Zoning Commission

September 19, 2022

HAMILTON TOWNSHIP ZONING COMMISSION

Revised Stage 2 PUD

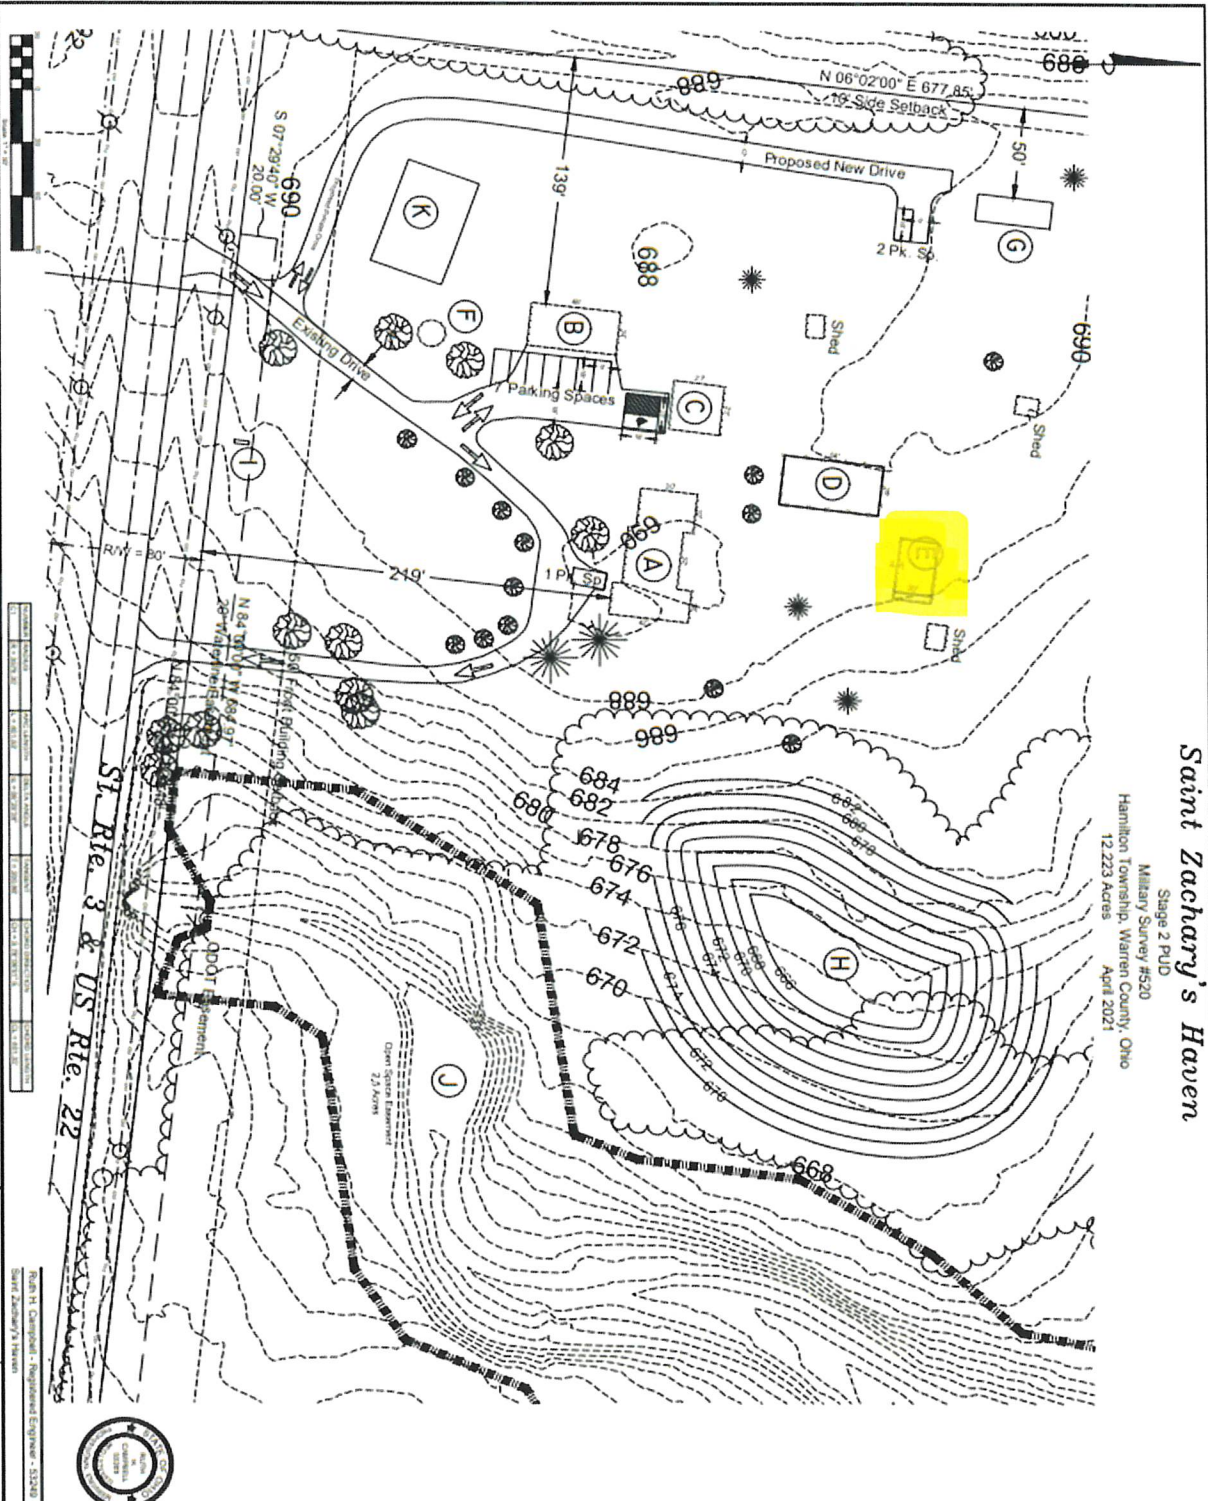
During Stage 2 and 3 all building dimensions were reviewed at which time the existing barn on site was set to be replaced by a 20' by 30' (600 sq. ft.) pole barn/meeting room. Letter E on the site plan below shows the location. The legend on the site plan indicates the dimensions of 20'x30'.

- Size:** 12.13 total acres.
- Zoning:** R-3 Multi-Family PUD
- Request:** The applicant is requesting a modification to the previously approved Stage 2 PUD plans to increase the size of the proposed pole barn used for community services. The size is increasing from 600 sq. ft. to 2560 sq.ft. (40 by 64) not including the porch or the lean-to. The applicant states that this change is necessary due to state requirements which have a minimum square footage needed for 15 residents. The proposed building has a men's and women's designated restrooms, a large meeting space, a storage closet, a large storage area with a garage door, a horse stall, 200 square foot porch, and a 768 square foot lean-to for outdoor storage totaling 3528 square feet. No other previously approved buildings are changing.

PUD Stage 3 Final Site Plan:

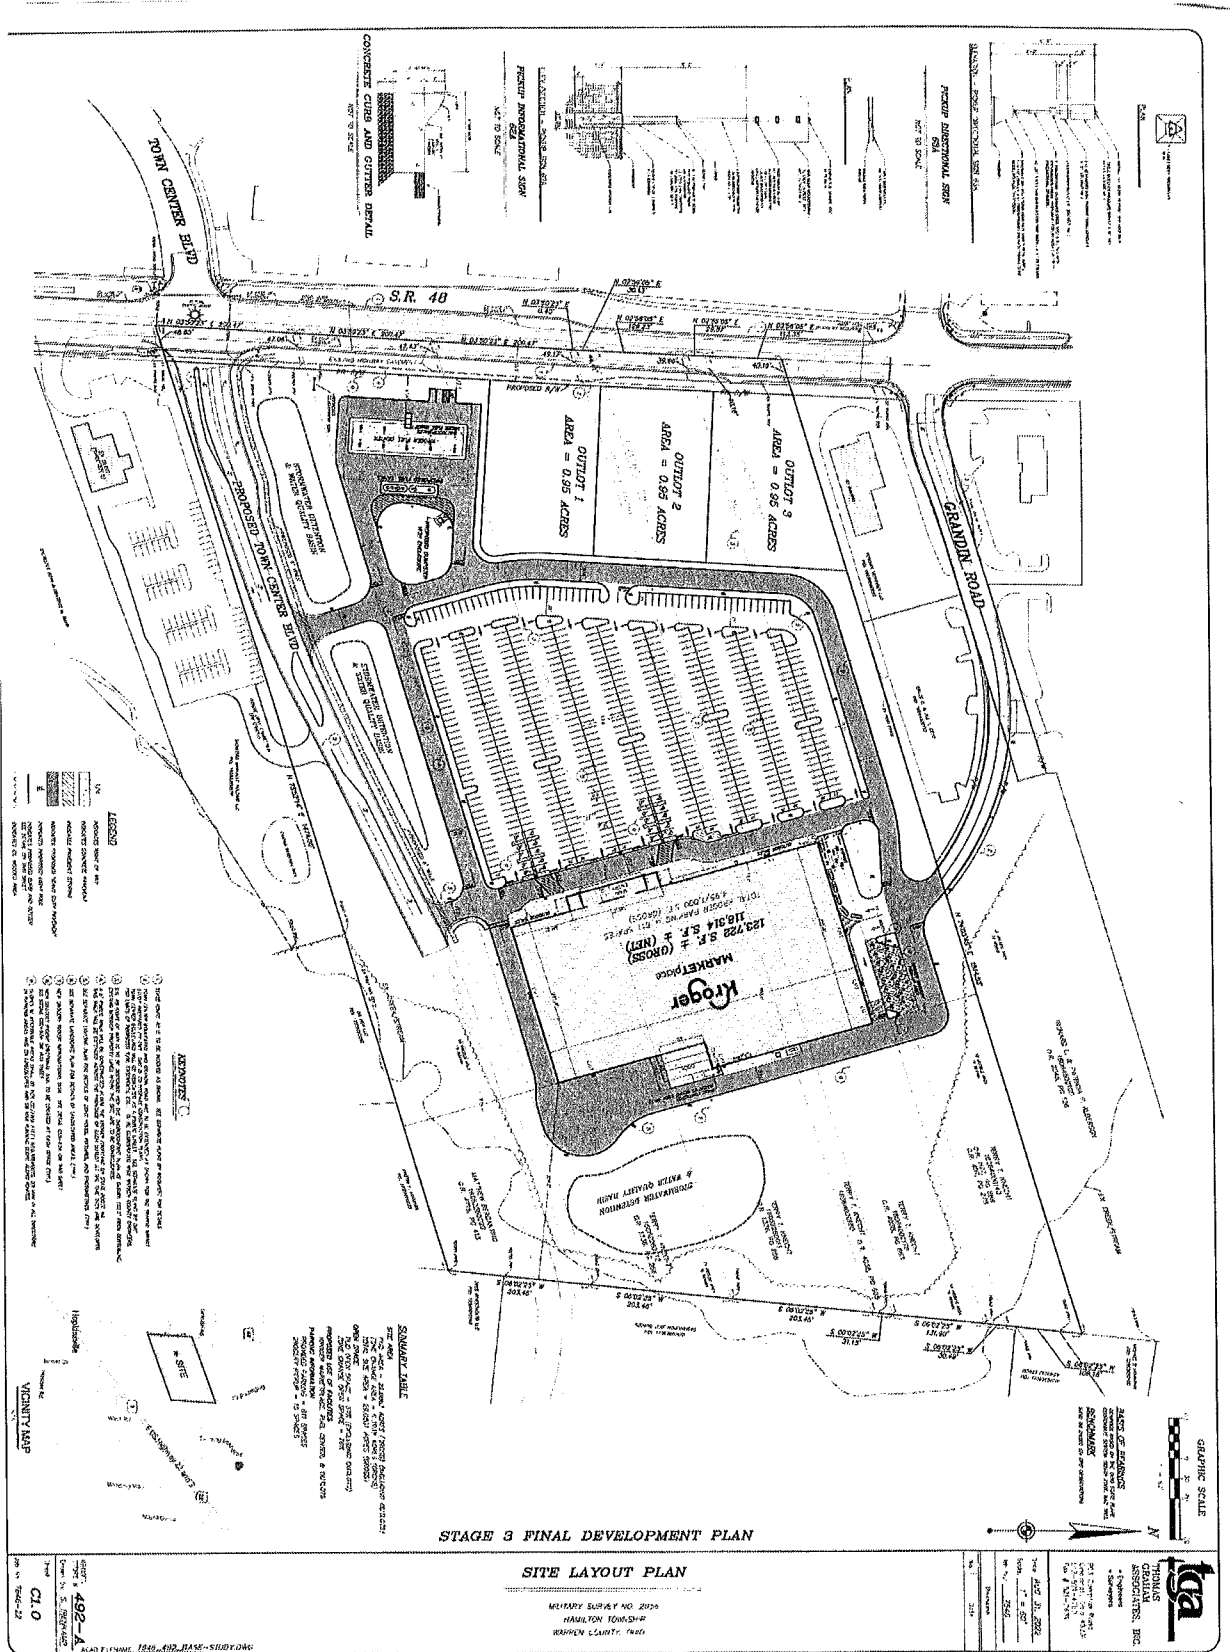
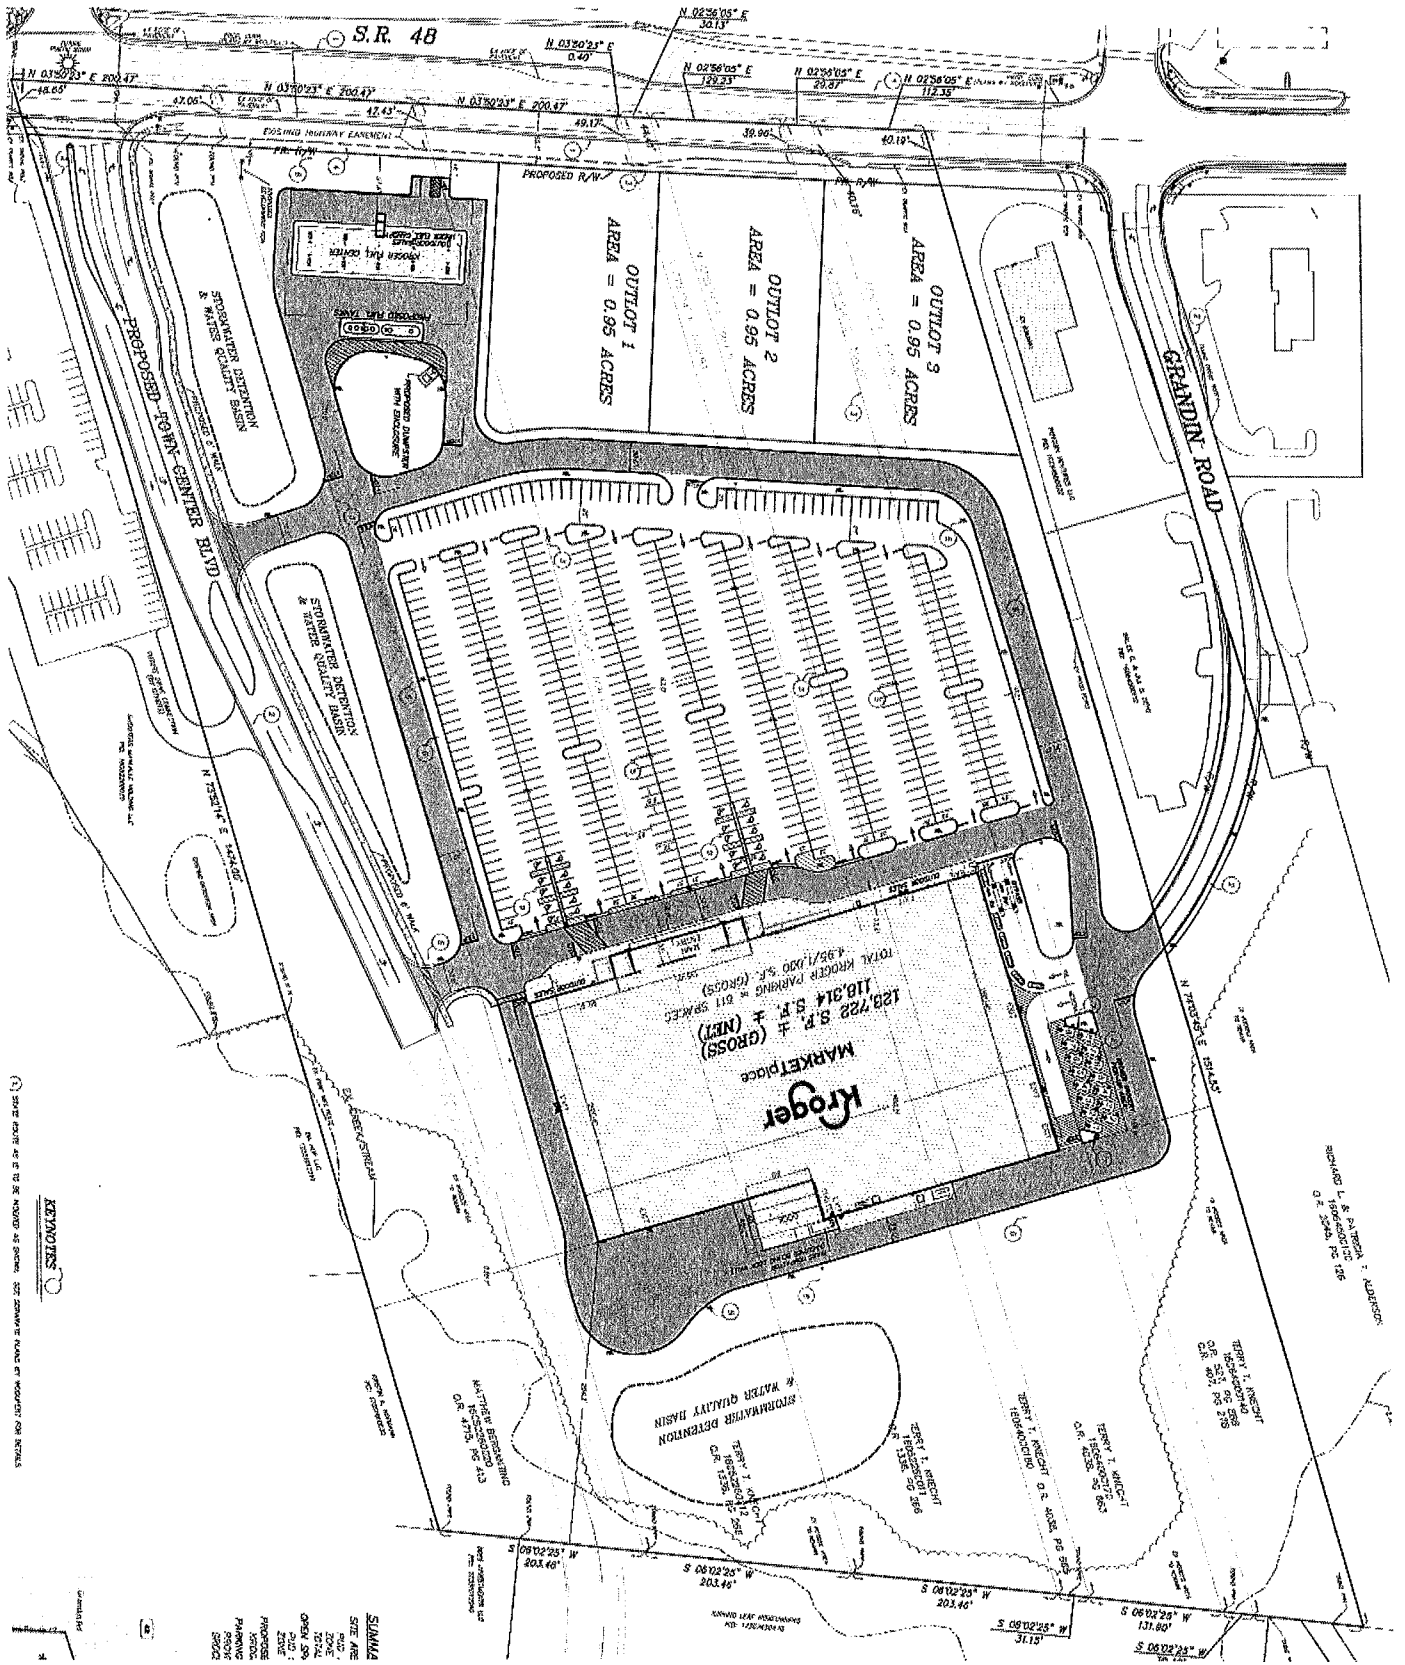
The applicant is proposing that a 6' public walk will be installed along the Kroger Frontage on State Route 48. This walk will be extended along the frontage of each outlot at the time they are developed. The plans do show that the 6' public walk will extend onto Towne Center Blvd. just to the west entrance site where there will be an internal connection from the Kroger store.
